Access Compliance Report

Public Rights-of-Way

Intersection ID: 3162	Main Street: SONG_SPARROW_LN	Cross Street: TOWHEE_CT	Location: W
ADA ID: 6A238676DCD3	Ramp Type: Perp	Initial Pass/Fail: Pass	Overall Compliance: No
			Severity Score: 2.5

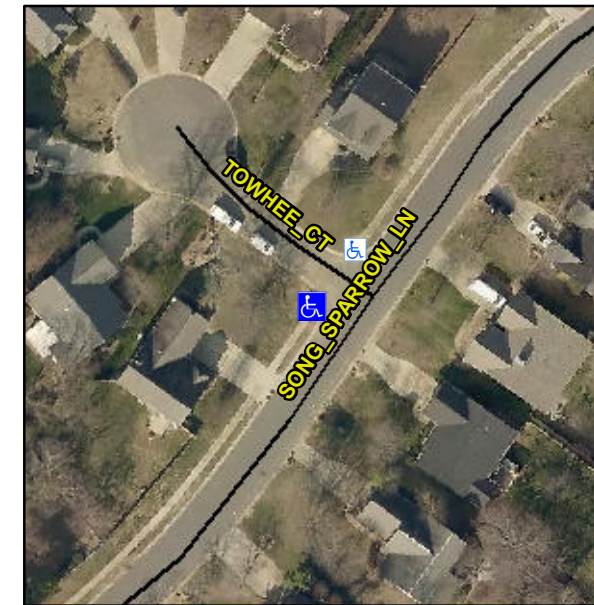
**R304.2.2-Perp, R304.3.2-Para,
R305.1.4, R304.5.3**

Compliance	Description	Data	Compliance	Description	Data
N/A	Ramp Length (in)	35.0	Yes	Ramp Slope (%)	5.3
Yes	Ramp Width (in)	98.0	Yes	Ramp XSlope (%)	1.2
N/A	Flare Type LT	Sloped	N/A	Flare Type RT	N/A
N/A	Flare Slope LT (%)	5.6	N/A	Flare Slope RT (%)	2.8
N/A	Flare Traversable LT?	No	N/A	Flare Traversable RT?	No
Yes	Landing Length (in)	48.5	Yes	DWS Provided?	Yes
Yes	Landing Width (in)	74.0	Yes	DWS Contrast?	Yes
No	Landing Slope (%)	6.0	Yes	DWS Length (in)	24.0
Yes	Landing X Slope (%)	0.9	No	DWS Full Width?	No
N/A	Landing Curb? (Y/N)	No	Yes	DWS Offset (in)	1.5
N/A	Shared Landing?	No			
Yes	Gutter Ponding?	No	Yes	Gutter Slope (%)	3.8
Yes	Gutter Lip Ht (in)	0.0	No	Gutter X Slope (%)	2.5
N/A	Painted X Walk1?	No	N/A	Painted X Walk2?	N/A
	X Walk 1 Direction	To NE		X Walk 2 Direction	N/A
N/A	X Walk 1 Width (in)	N/A	N/A	X Walk 2 Width (in)	N/A
	X Walk 1 Slope (%)	0.5		X Walk 2 Slope (%)	N/A
	X Walk 1 X Slope (%)	1.1		X Walk 2 X Slope (%)	N/A

**Remove & Replace Entire Ramp.
Remove & Replace Gutter.**
